MR 73

SERVICE INFORMATION

SERVICE BULLETIN

FM-RF AMPLIFIER MODIFICATION

BOTTOM VIEW

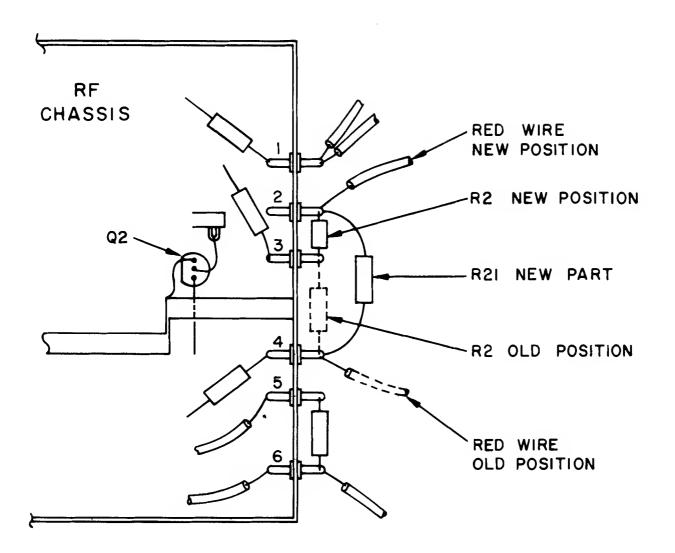
PURPOSE OF MODIFICATION: To decrease power dissipation in transistor Q2

WHAT UNITS ARE AFFECTED: Serial No. 10701 to 27784 Only.

WHEN MODIFICATION SHOULD BE MADE: When the customer complains that FM sensitivity has decreased or FM tuner has become noisy.

- Step 1 Remove bottom cover and bottom cover of RF front end.
- Step 2 Replace transistor Q2. Be sure leads are of same length and have same positioning as used on original transistor.
- Step 3 Counting from the front of the tuner, locate the fourth feed-thru capacitor on the left side of the RF front end. Remove the red lead and connect it to the unused second feed-thru capacitor. Remove the 220Ω 10% 1/4W resistor (R2) connecting between feed-thru capacitors 3 and 4, and connect this resistor between feed-thru capacitors 2 and 3. Connect the new 220Ω 10% 1/4W resistor (R21) between feed-thru capacitors 2 and 4.
- Step 4 Replace both covers.
- Step 5 Check performance of tuner. Perform alignment steps 6 and 7 as in Service Manual if necessary to meet performance specifications. To perform alignment remove the cover from the top of the RF front end.
